Review of Proposed Sewage Works

Lot 28, Concession 9, Wahwashkesh Lake, Municipality of Whitestone, ON

Pinchin File: 318638

PROPOSED SUBDIVISION LAYOUTS

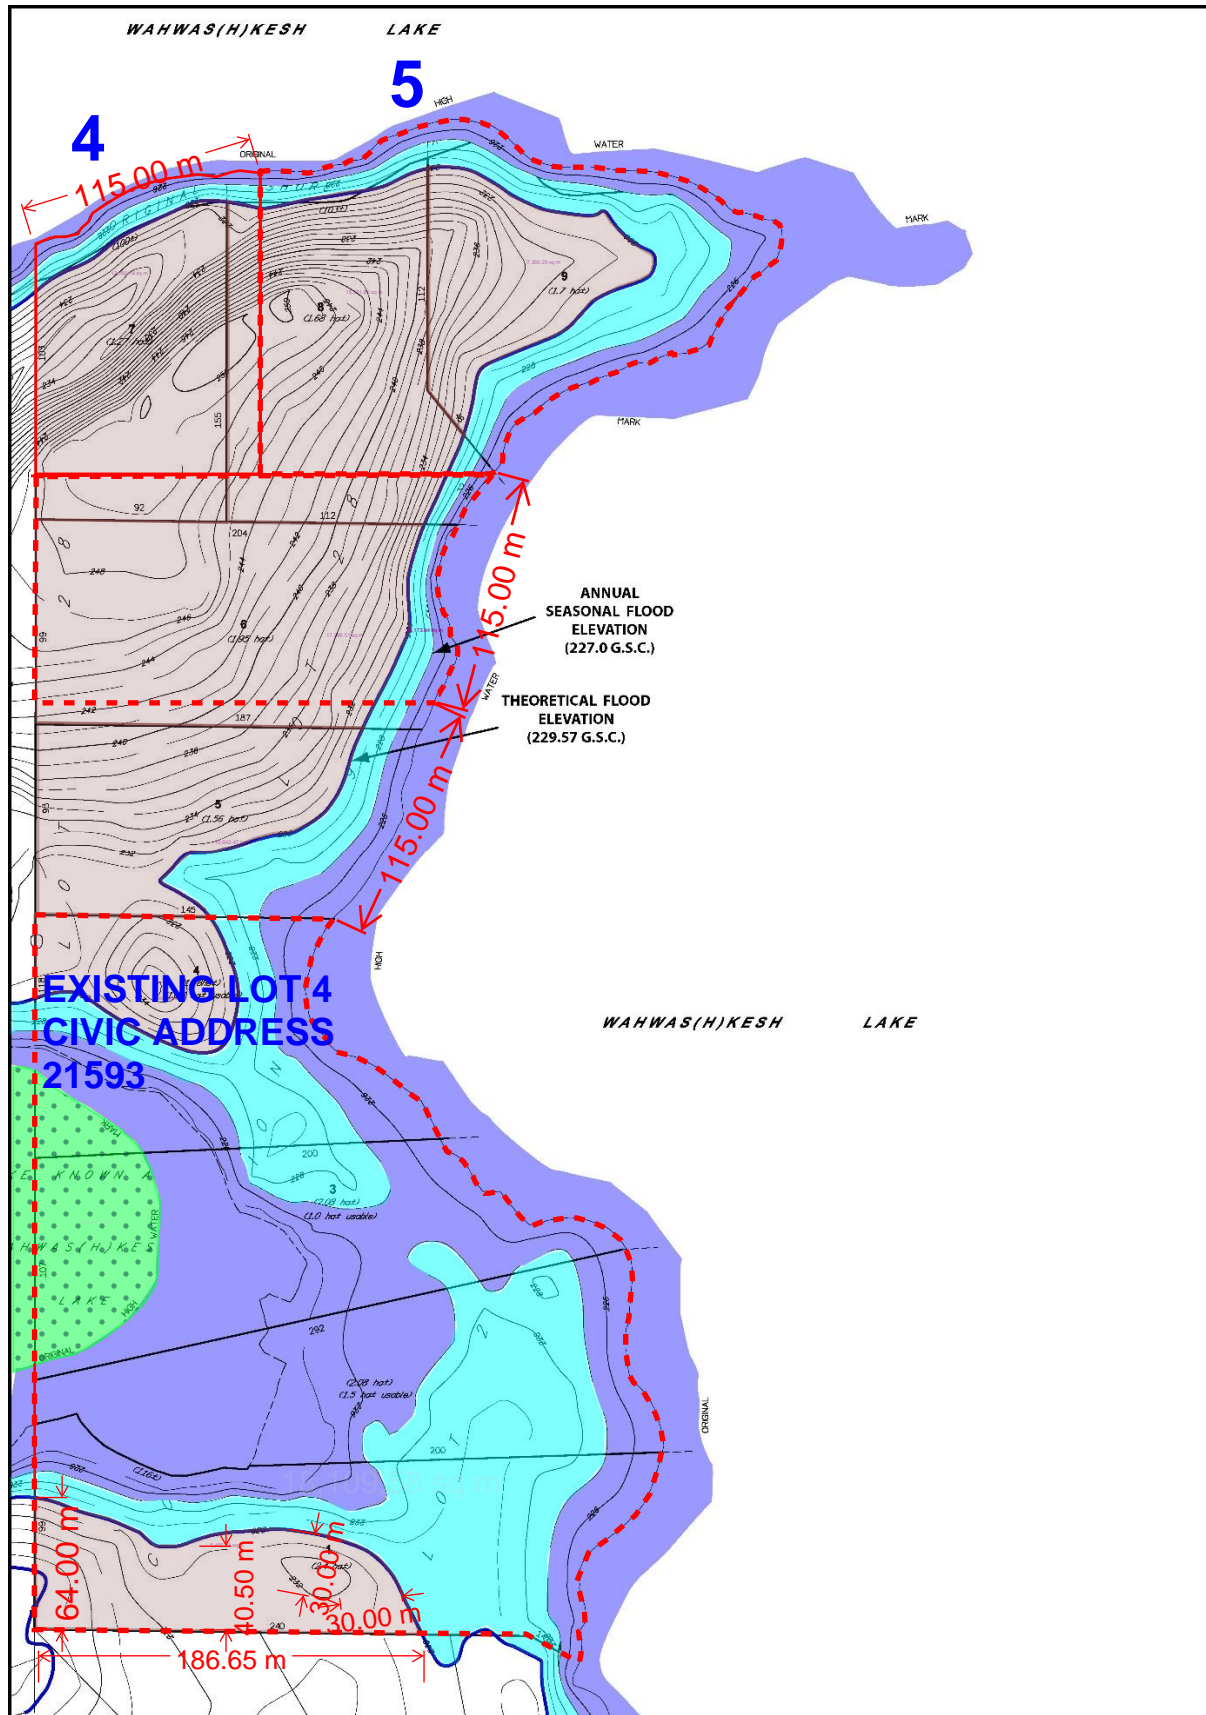
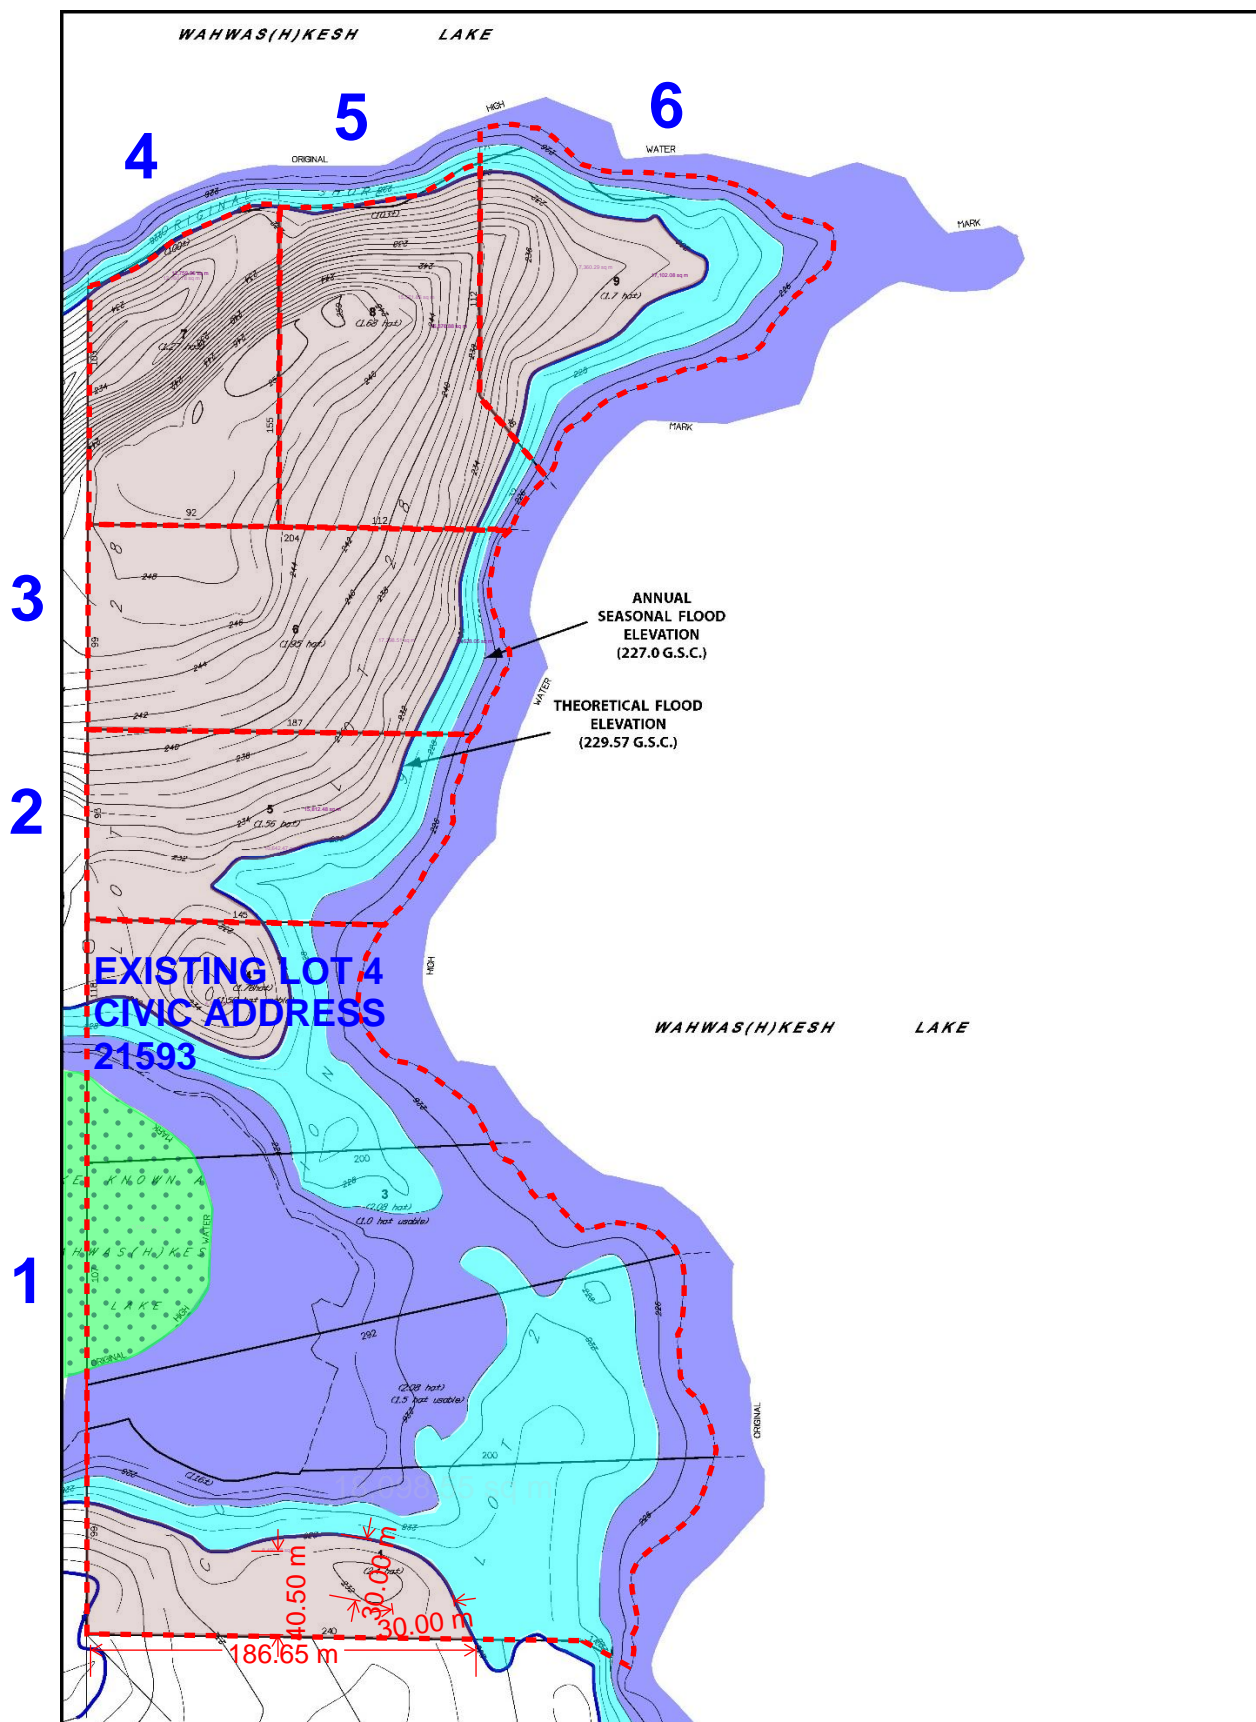
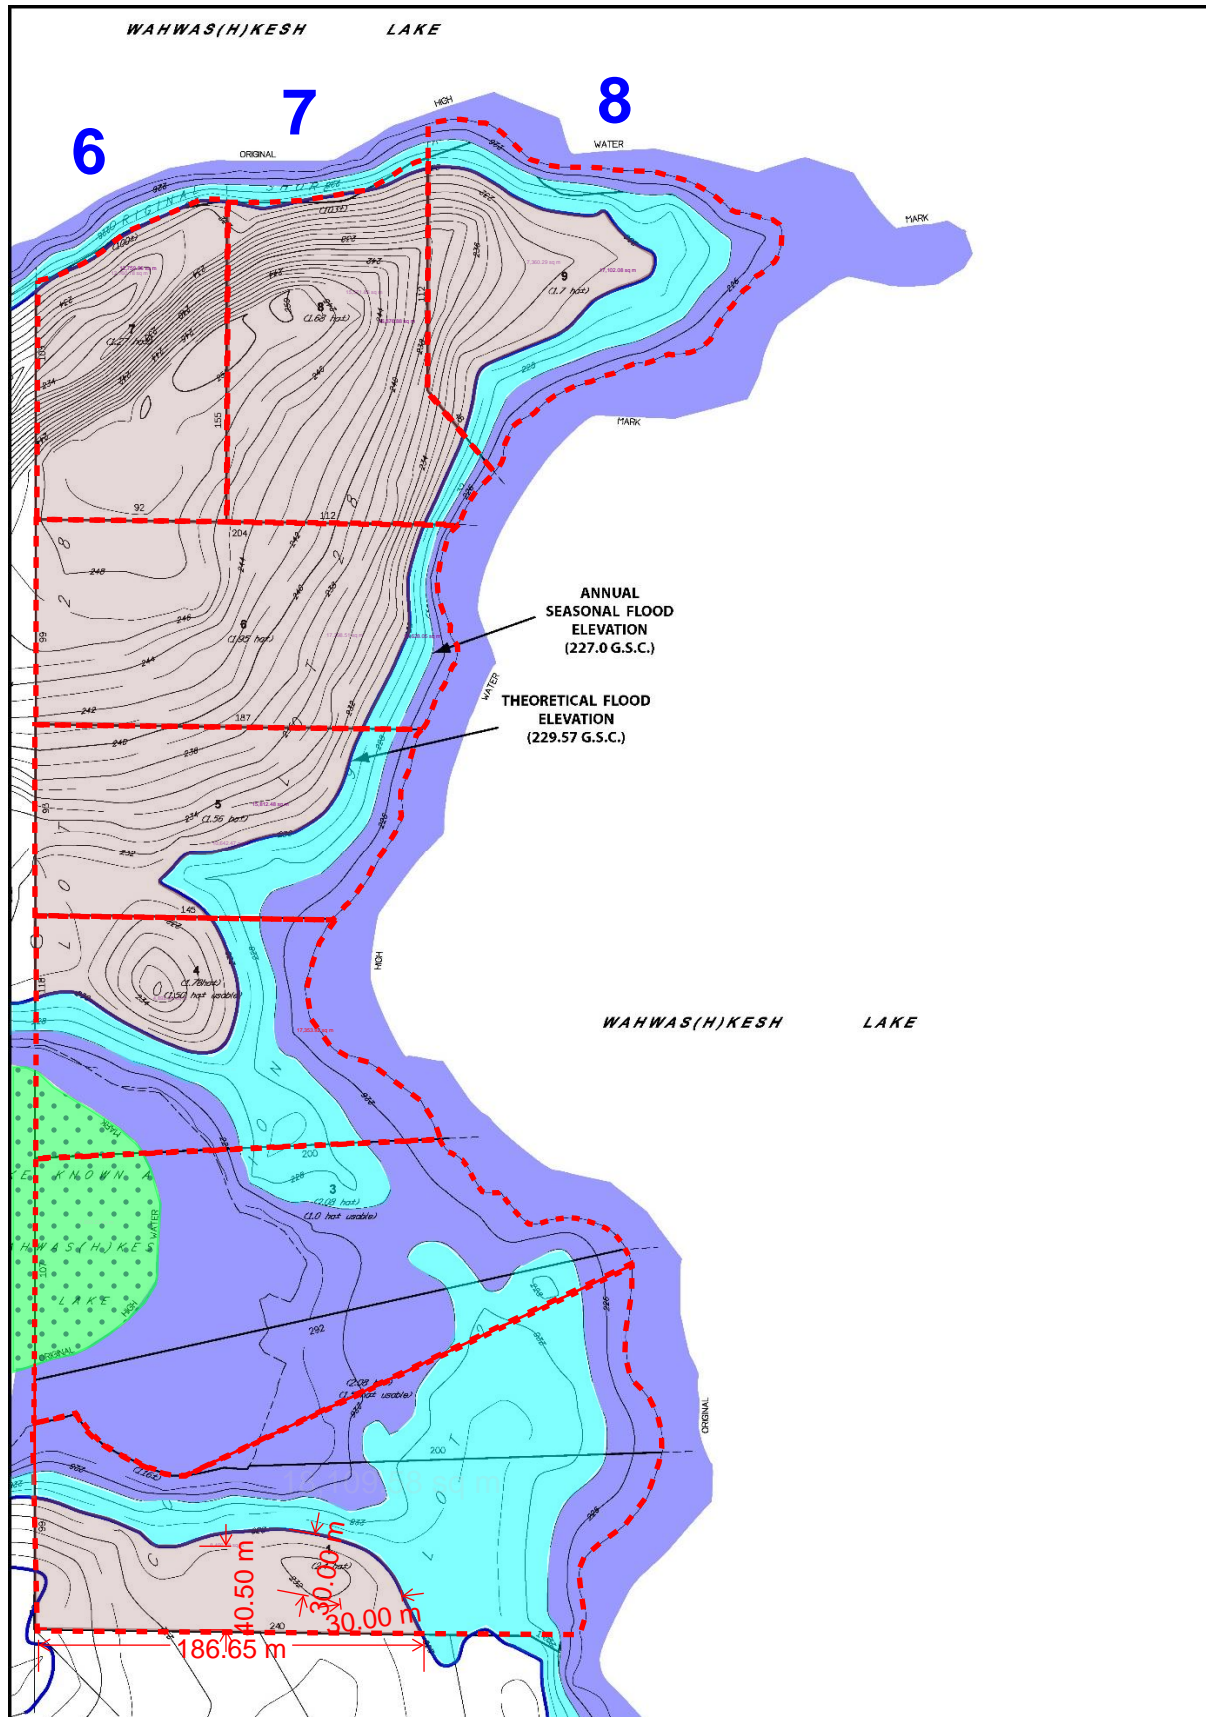
The Client is concerned that there is insufficient space available on the subdivided lots and that the sewage works (septic tank and leaching beds) to be located within the 100-yr flood zone.

It's Pinchin understanding that three (3) layouts/configurations exist for the proposed development. The proposed configurations include subdividing Lot 28 into the following:

- Eight (8) lots, and building eight (8) individual units;
- Six (6) lots, and building six (6) individual units; or
- Five (5) lots, and building five (5) individual units.

DRAWING NAME:
Flood Elevations and Setbacks

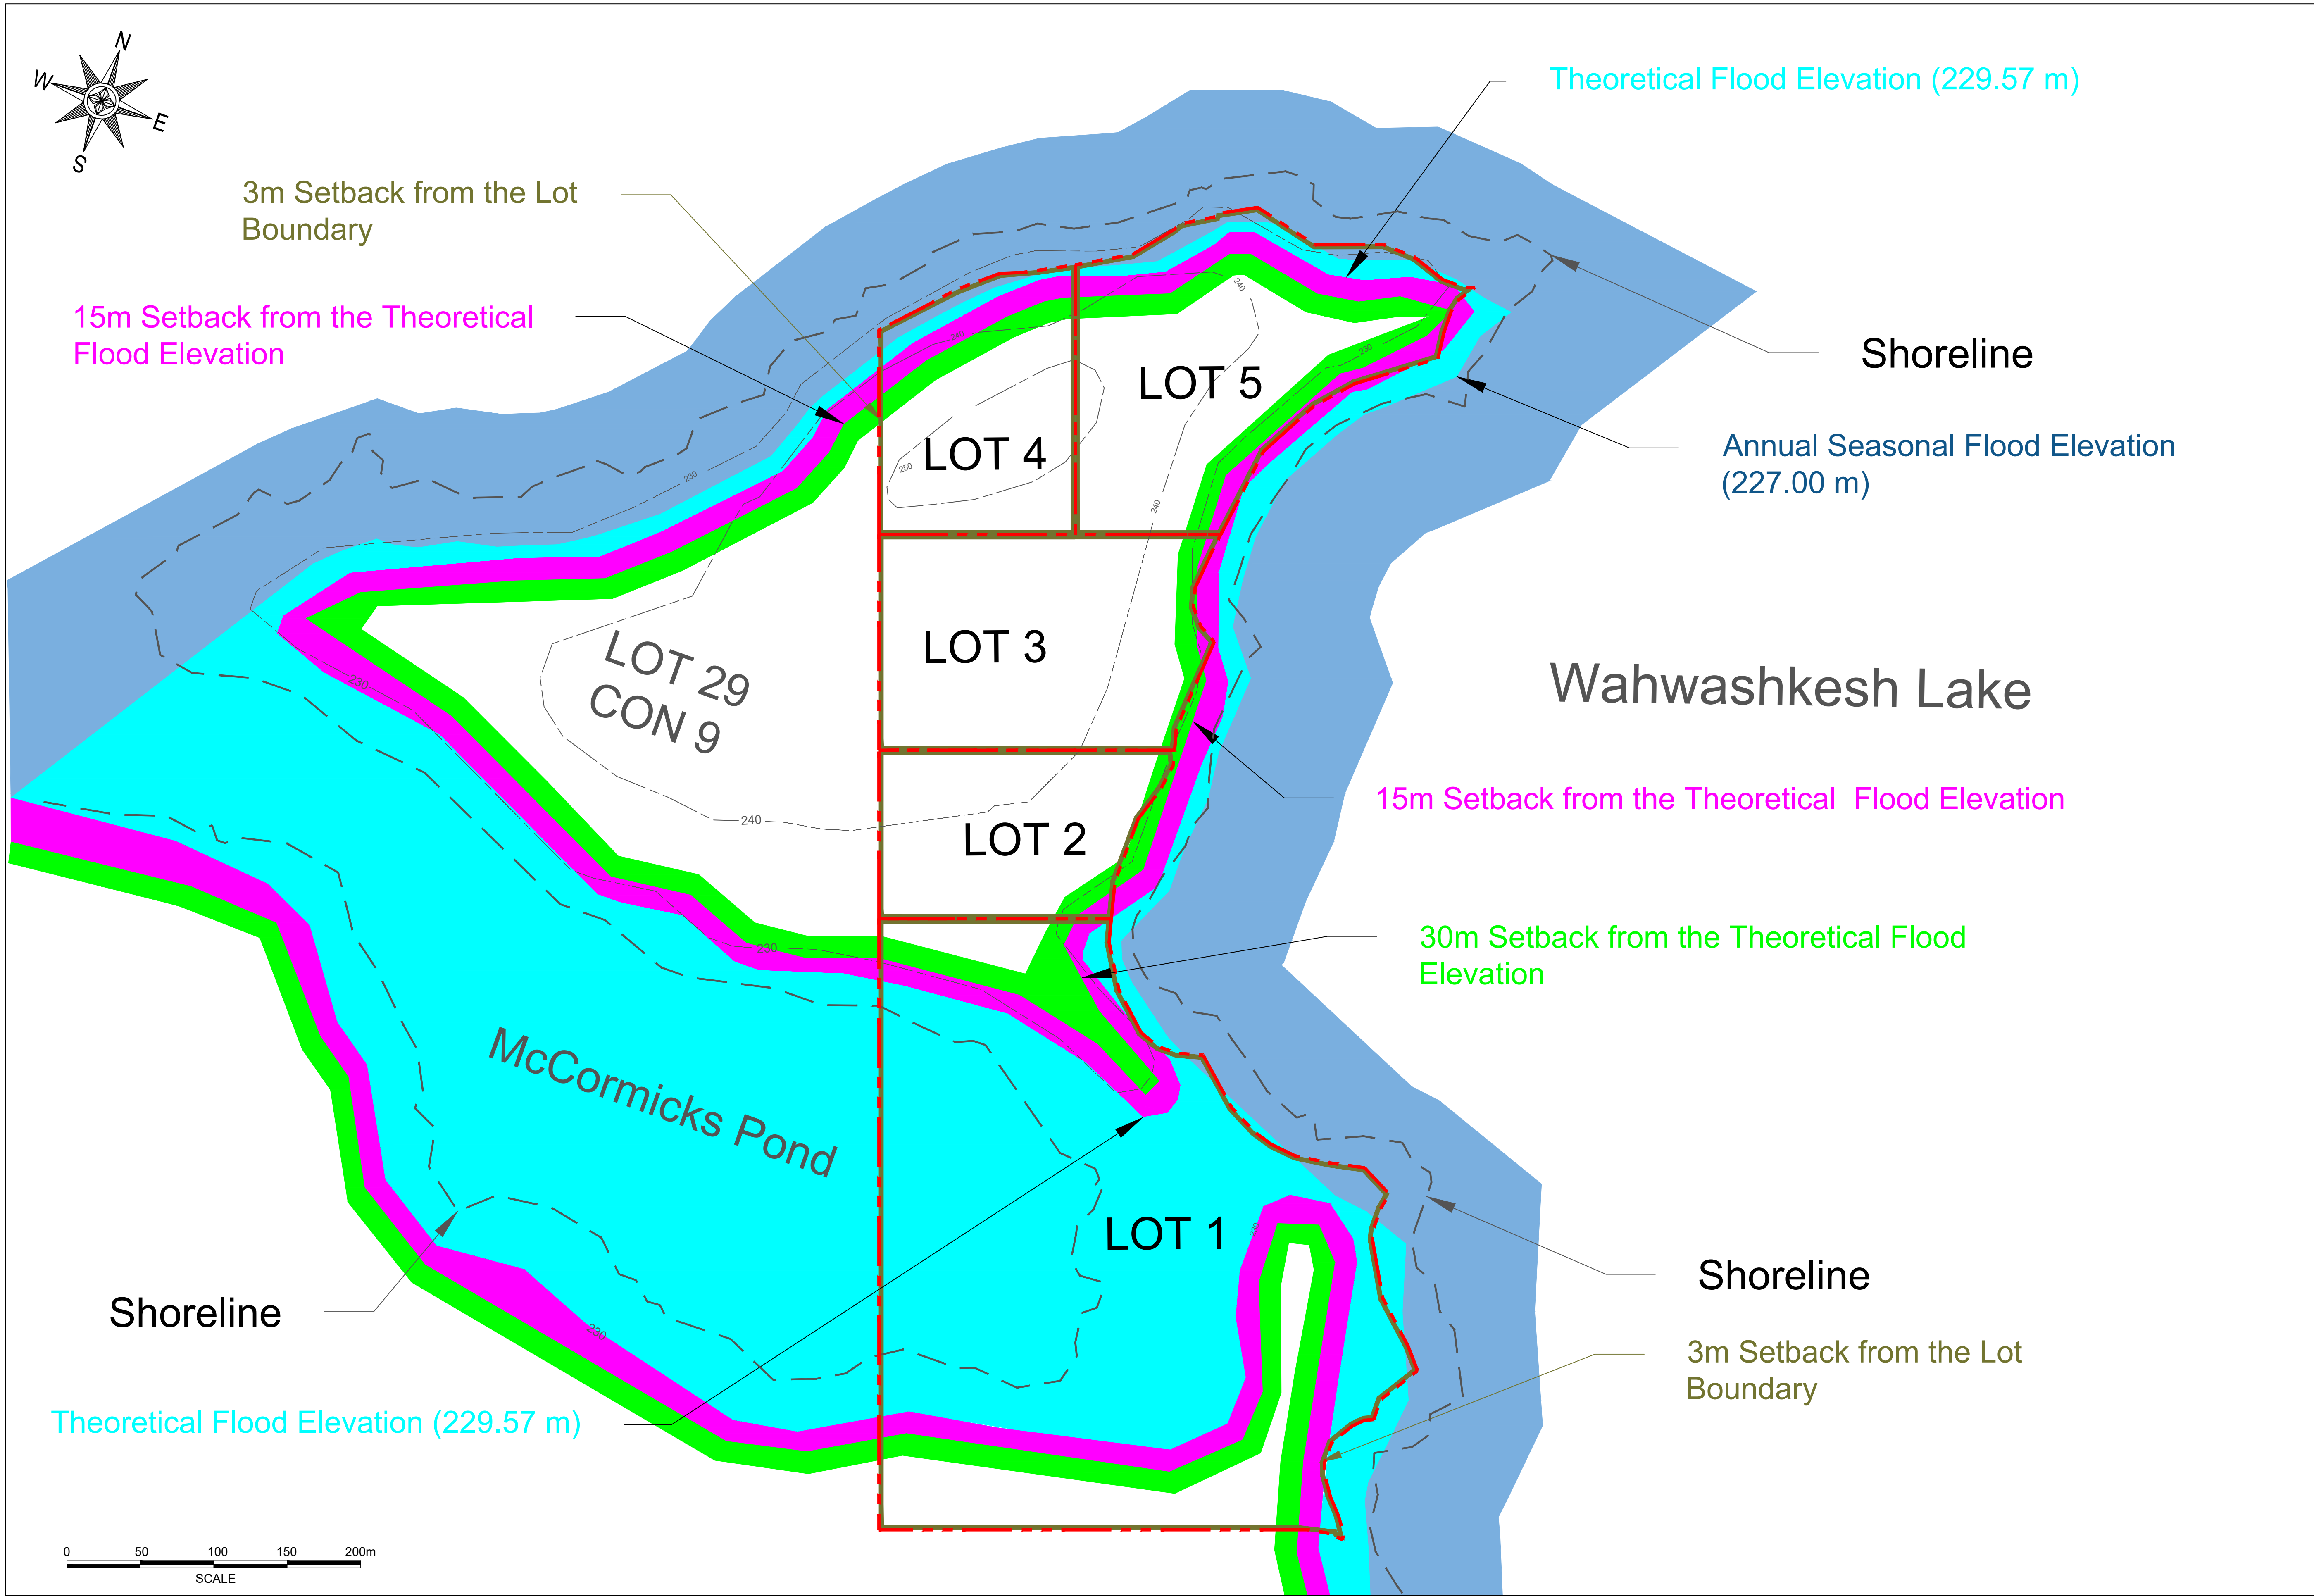
Based on the available information and the requirements of the OBC, the leaching beds (if built) should be constructed as raised beds such that the bottom of the absorption trench is at least 900mm above the higher of:

- i) The regulatory flood elevation (high water elevation); or
- ii) Soil with a t-time greater than 50 min/cm (bedrock)

Since the native soil (bedrock) has a t-time greater than 50 min/cm, a mantle extending 15m down gradient of the leaching bed is required. This mantle must also be above the high-water elevation.

This will also satisfy the requirements of the Table 8.2.1.6.B of OBC whereas distribution piping (leaching bed) must be setback a minimum of 15m mantle from a lake. It should be noted that the Whitestone Septic Policy recommends that a leaching bed be setback a minimum of 30m from the shoreline of the lake where possible.

1. The sewage works only be construction in locations with a minimum starting elevation of 229.57masl and be setback from this elevation so that they,<the sewage works>, meet the minimum requirements of the OBC and the Whitestone Septic Policy. This will allow the sewage works to avoid the high-water level, thus meeting the requirements of the OBC, and maintain proper operation in the event of a flood; and
2. For all lots, determine the maximum footprint and occupancy (no. of bedrooms) of the proposed dwellings that will allow the sewage works to be installed such that they meet the requirements and setbacks of the OBC of the Whitestone Septic Policy.
